LIGO-E1100050-v4

Responses to ACB FDR Questions

This document presents the answers to the AOS SLC Arm Cavity Baffle design review committee. The questions were posed in M1100009-v1.

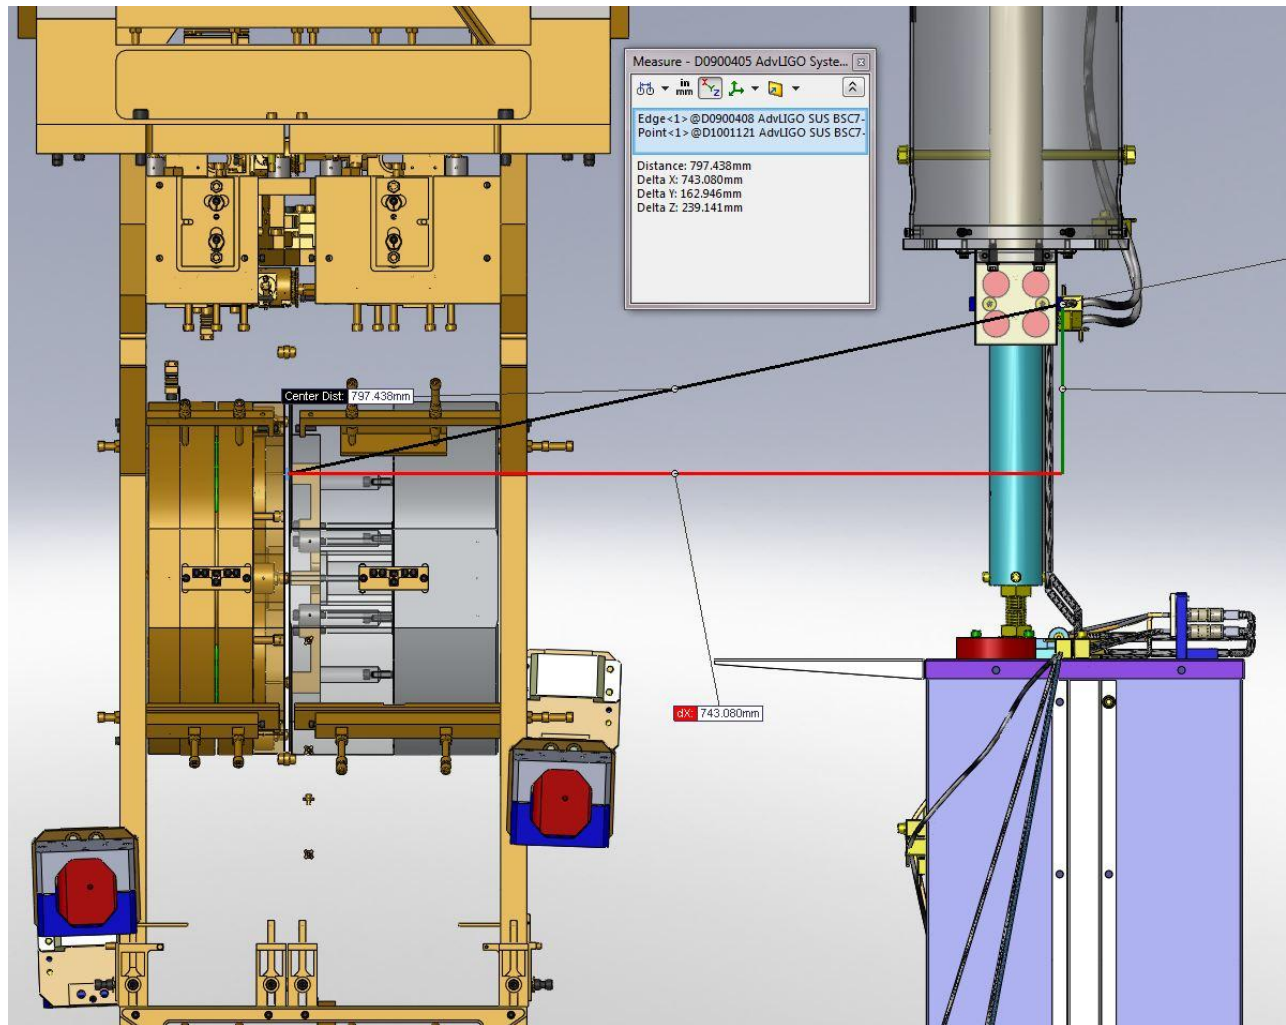
Compared to the previous version, this document, [Magnetic Field Measurements](#), contains the correct analysis of the magnetic field using a power law; according to the magnetic induction approximation formula analogous to the electric dipole approximation

The results of those measurements and extrapolations from the fit show that the magnetic field spectrum at a distance of **0.7m** is estimated to be about $1 \text{ pTrms}/\sqrt{\text{Hz}}$ above 10Hz, a value one order of magnitude lower than the natural magnetic field measured at Hanford. Considering that the expected seismic noise on a Caltech's build third floor is presumably larger than the one at the sites, the spectrum noise is dominated by the instrument noise, and the number of permanent magnets used will be reduced by a factor two, the residual magnetic field spectrum estimation at a distance of 0.7 m is conservative.

The following figure shows the location of the ACB magnetic with respect to the TM SUS magnets; the actual distance is 797 mm (the ACB magnet plate will be rotated 90 deg away from the TM SUS in this figure).

Figure 10: Clamping Detail for the ACB Top Mounting Plate

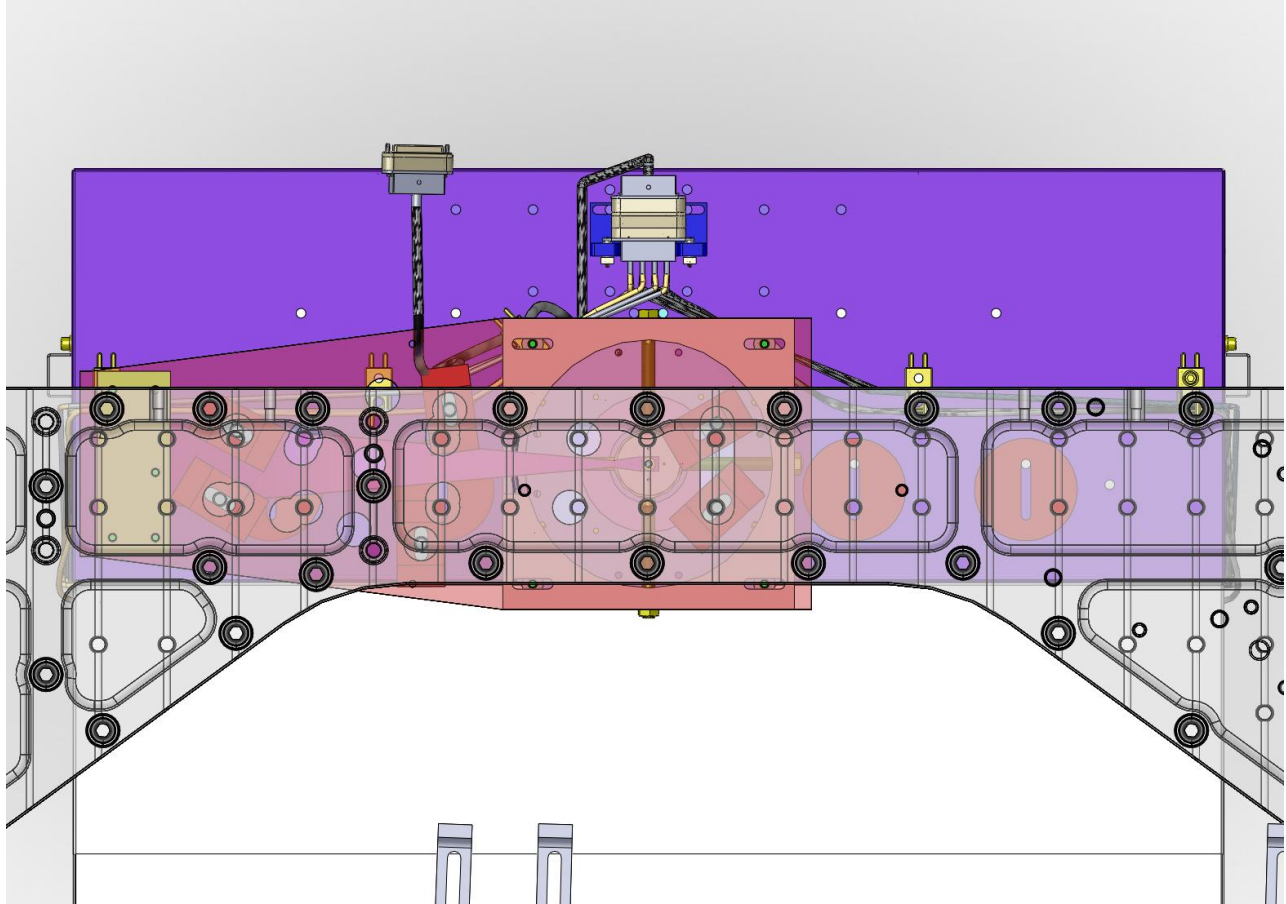
Clamping to stage 0. In T1000747 figures 18 and 20 are not consistent. Please work with systems to update the layout of all of the ACB wrt stage 0 to confirm clamping option proposed will in fact work.

A clear view of the clamping arrangement is in Figure 10.

Figure 11: ACB Shown Hanging with 3 Deg Tilt

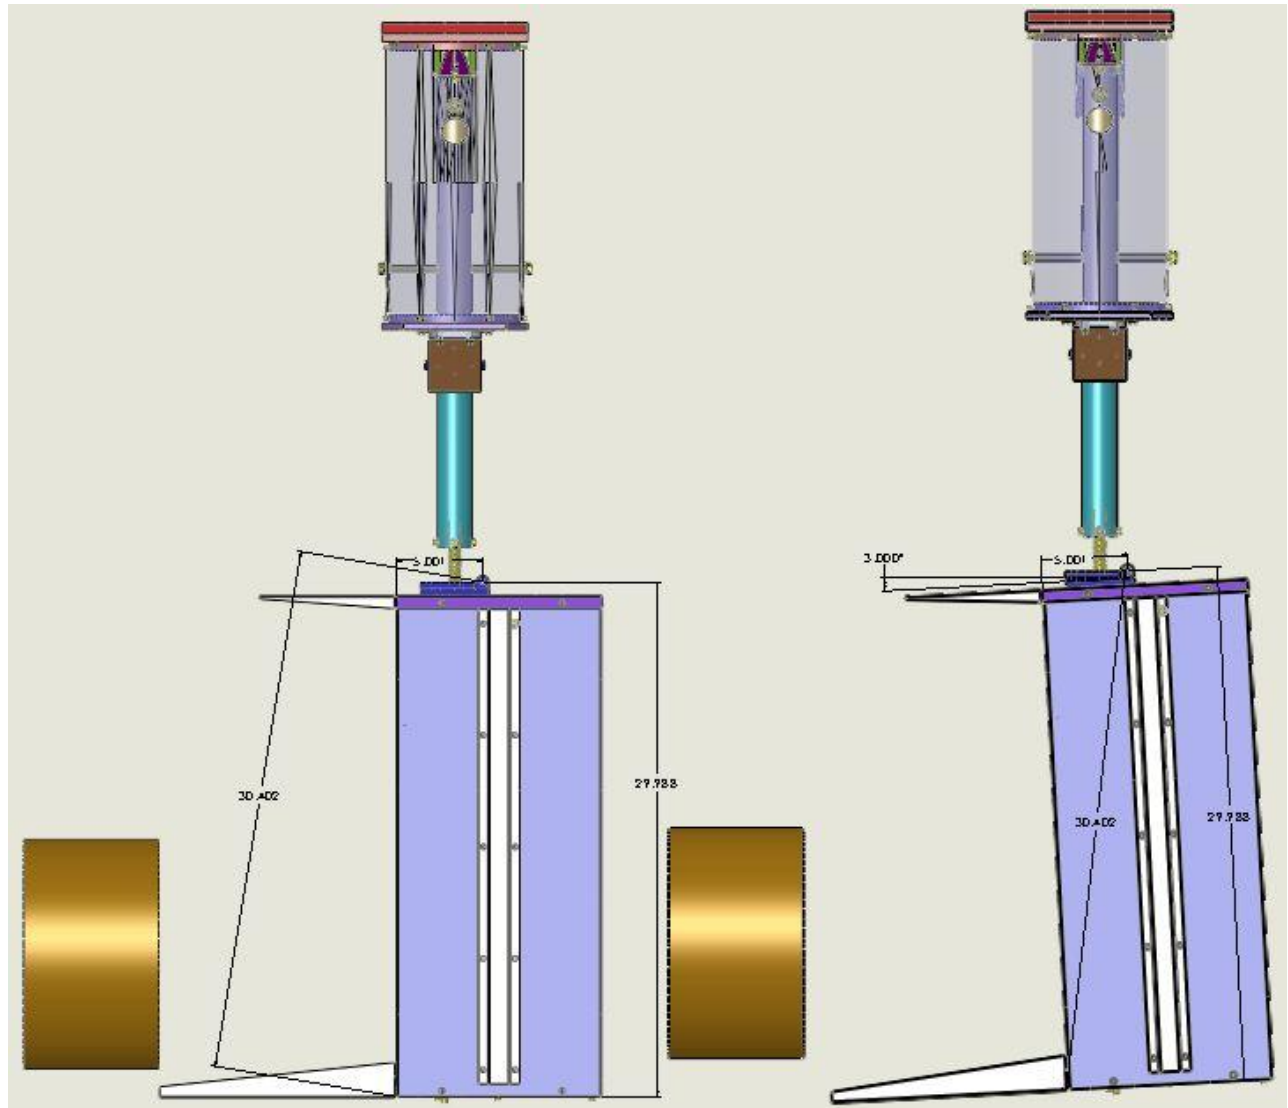
Do we have a glint line in the bend, apex of the V? ACTION - Analysis is required on this. Could a 5 deg tilt be included in design and would this be adequate?

I measured the BRDF of a typical porcelainized steel sample and calculated the glint from the baffle edges and apex bend using measured BRDF function. The edge glint is negligible when the baffle is tilted forward by 1 deg.

The present baffle design will be hung at a 3 deg tilt by placing a wedged washer between the hinge plates.

Figure 12: Total Displacement Noise ACB Scatter Versus Tilt Angle

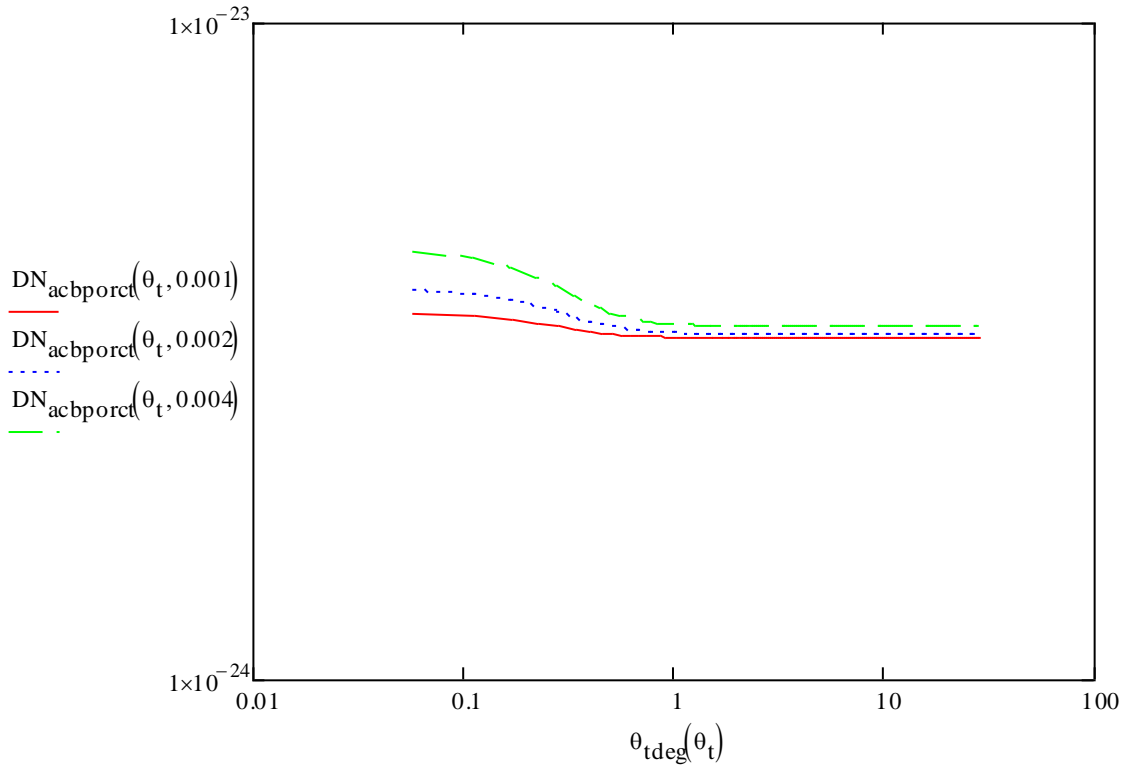
14) ACTION on Mike Smith - Tilting BRDF - need to look at again? - URGENT!! Worried this could impact design.
